HISTORIC AND DESIGN REVIEW COMMISSION

April 19, 2017

HDRC CASE NO: 2017-175
ADDRESS: 306 LAMAR ST
LEGAL DESCRIPTION: NCB 528 BLK 1 LOT N 105 FT OF W 28.08 FT OF 2 & E 24 FT OF 2
ZONING: R-5 H
CITY COUNCIL DIST.: 2
DISTRICT: Dignowity Hill Historic District
APPLICANT: Jalan Moharam
OWNER: Jalan Moharam
TYPE OF WORK: New construction of a single family structure and rear accessory structure
REQUEST:

The applicant is requesting conceptual approval to: construct a single family house and accessory structure at 306 Lamar.

SITE PLAN

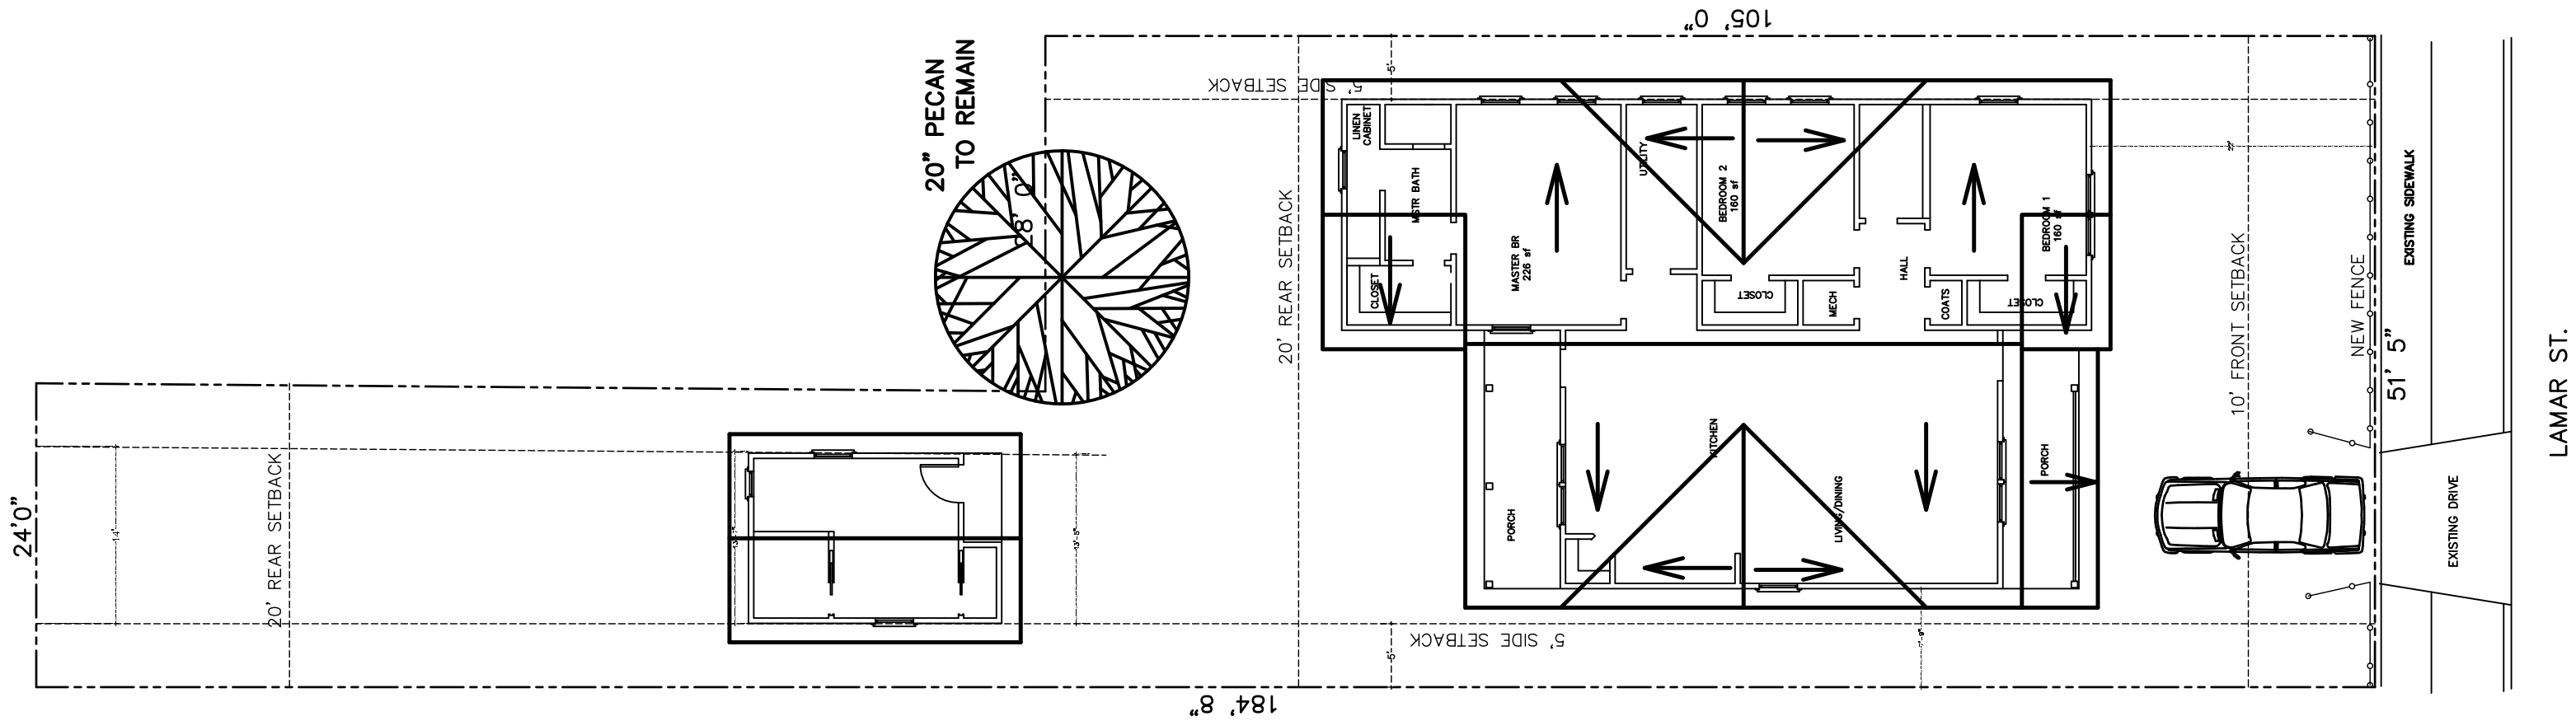
- p. **REAR DRIVEWAY** – The applicant has noted that the proposed driveway will be located to provide access to the site from Fayn Way. Staff finds the proposed driveway location appropriate and consistent with other driveways located at the rear of properties. The proposed driveway's width however, is inconsistent with the Guidelines. The Guidelines for Site Elements 5.B.i. note that driveways should not exceed ten (10) feet in width. Staff recommends the applicant reduce the proposed driveway width to no more than ten (10) feet in width.

- q. **FRONT DRIVEWAY** – The front of the property currently features a curb cut and driveway approach. The applicant has proposed to include a front yard parking location to be immediately in front of the proposed front porch. This is not consistent with the Guidelines for Site Elements 7.A.ii.

- t. **LANDSCAPING** – The applicant has provided a landscaping plan, that as noted in finding p notes the installation of front yard parking. This is not appropriate. Additionally, the applicant has noted the remove of front yard grass and the installation of xeriscaping. Per the Guidelines for Site Elements, fifty (50) percent of front yard grass is to remain.

ELEVATIONS

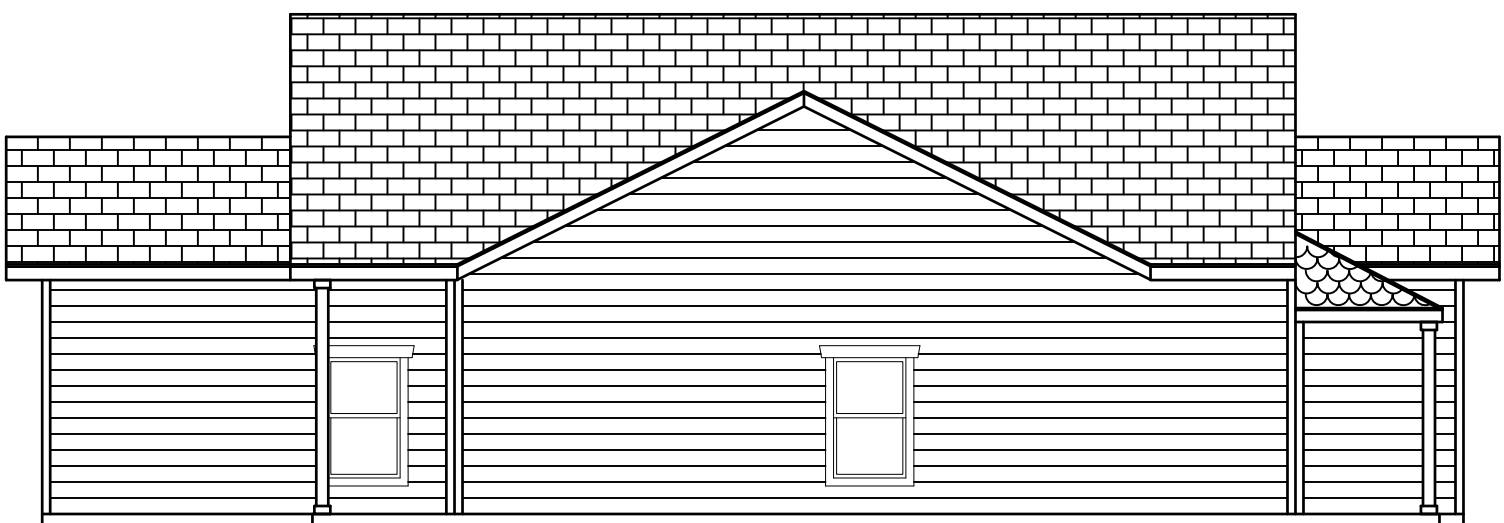
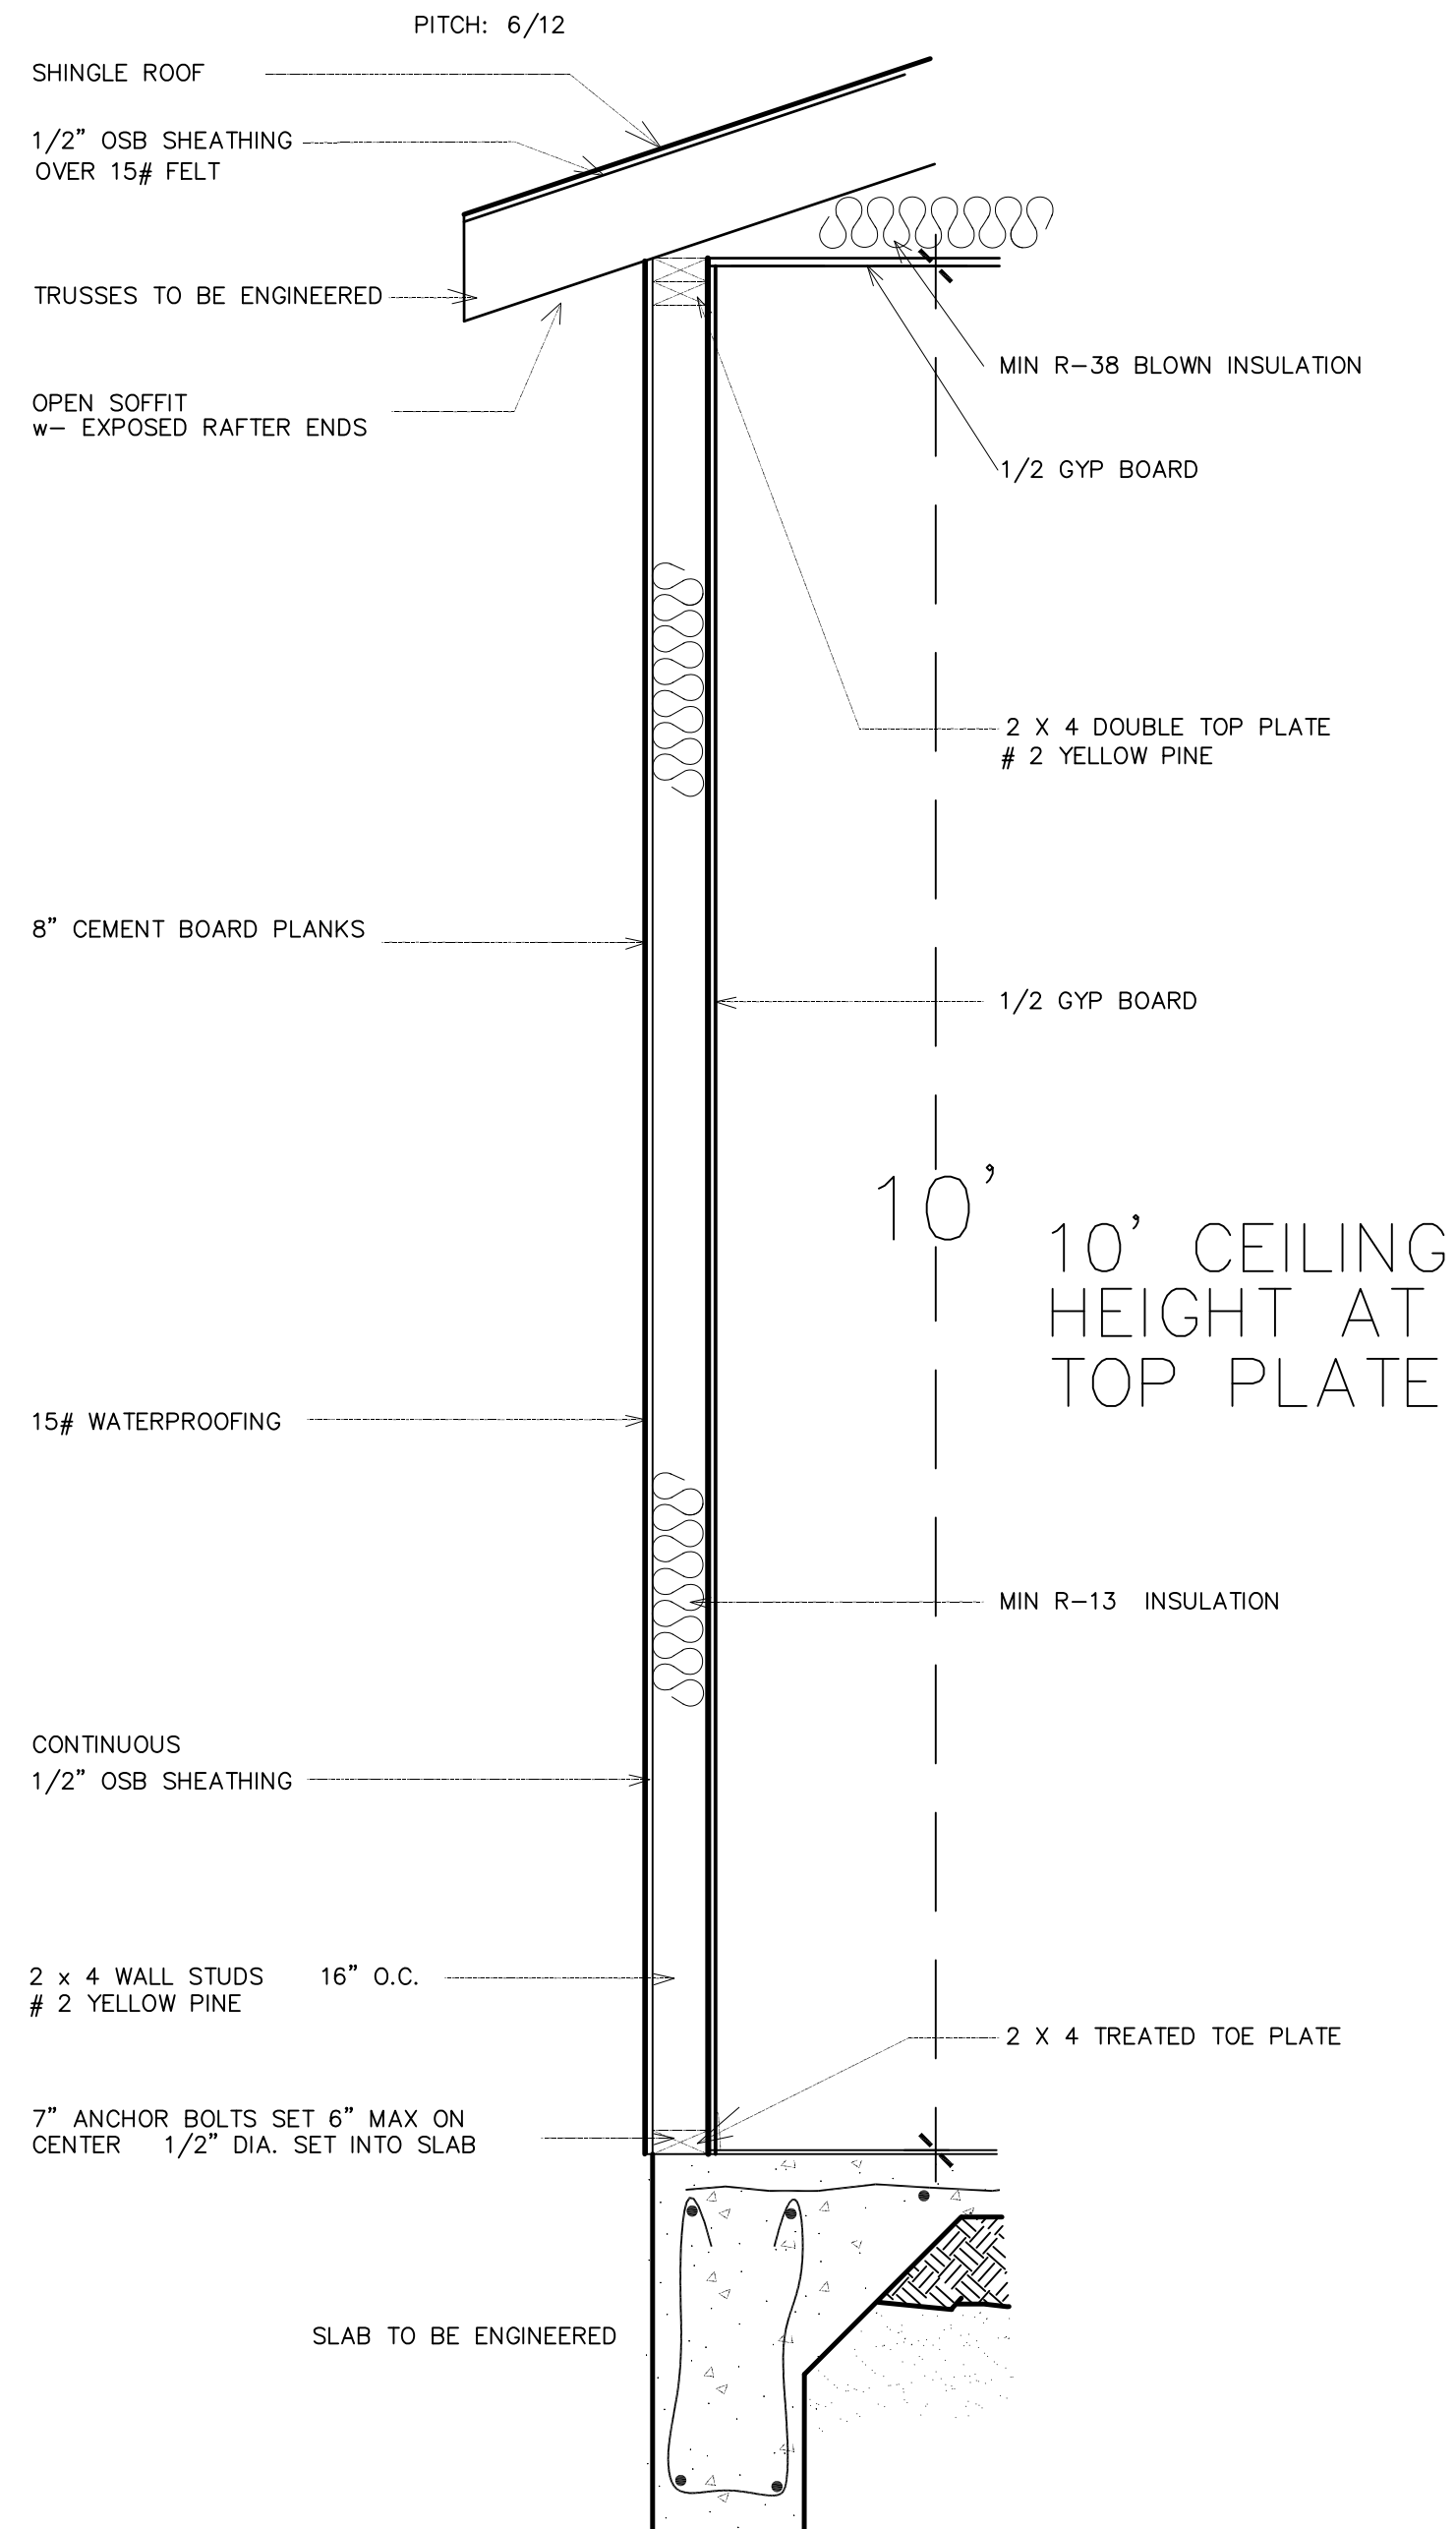
- f. **SCALE & MASS** – Per the Guidelines for New Construction 2.A.i., a height and massing similar to historic structures in the vicinity of the proposed new construction should be used. The applicant has proposed a one story structure with an overall height that is consistent with the height of historic structures found on this block of Lamar; however, the proposed width of the structure is not consistent with the historic examples found in the district. The proposed width should be reduced to be consistent with the historic houses in the district.

- g. **FOUNDATION & FLOOR HEIGHTS** – According to the Guidelines for New Construction 2.A.iii., foundation and floor height should be aligned within one (1) foot of neighboring structure's foundation and floor heights. Historic structures on this block feature foundation heights of approximately two to three feet. The applicant has proposed a minimal foundation height that is not consistent with the Guidelines.

- h. **ROOF FORM** – The applicant has proposed roof forms that include two front gabled roofs, side gabled roofs and a front sloping shed roof. Generally, these roof forms are found throughout the district; however, in the manner that they have been incorporated into the proposed new construction is inappropriate. Staff recommends the applicant revise the proposed roof form to include simple front and side gables.

- i. **WINDOW & DOOR OPENINGS** – Per the Guidelines for New Construction 2.C.i., window and door openings with similar proportions of wall to window space as typical with nearby historic facades should be incorporated into new construction. On the front façade, the applicant has proposed double window that feature an inappropriate mullion width. On the side elevations the applicant has proposed windows that feature a sill and head height that are inconsistent with those found in historic structures in the neighborhood. Additionally, the proposed window proportions are not consistent with those found historically in the district.

- l. **ARCHITECTURAL DETAILS** – New building should be designed to reflect their time while representing the historic context of the district. Additionally, architectural details should be complementary in nature and should not detract from nearby historic structures. Generally, staff finds the proposed massing, footprint and materials appropriate and consistent with the Guidelines; however, as noted in finding g, the proposed roof form features proportions that are not found historically throughout the Dignowity Hill Historic District.

- m. **FRONT PORCH DESIGN** – The applicant has proposed a front porch that is integrated into the massing of the proposed new construction, generally consistent with the historic massing of front porches. The applicant has proposed front porch railings that are not appropriate for the proposed front porch. Historic structures in the Dignowity Hill Historic District rarely feature ground level porch railings.

- n. **COLUMN DESIGN** – The applicant has proposed for the structure to feature two front porch columns. At this time, the applicant has not provided information noting the detailing of the proposed columns. Staff recommends the installation of a column that features at least five (5) inches in width and depth that features capital and base trim.

Staff does not recommend conceptual approval at this time. Staff recommends the applicant modify the proposed roof forms as noted in findings g and k, remove the proposed front porch railings as noted in finding l, confirm that the proposed setback is consistent with those of neighboring historic structures as noted in finding c, propose a width that is consistent with those found in the district as noted in finding f, incorporate appropriate window openings as noted in finding h, remove the front yard parking location as noted in finding p, retain fifty percent of front yard grass and provide additional information in regards to column design.
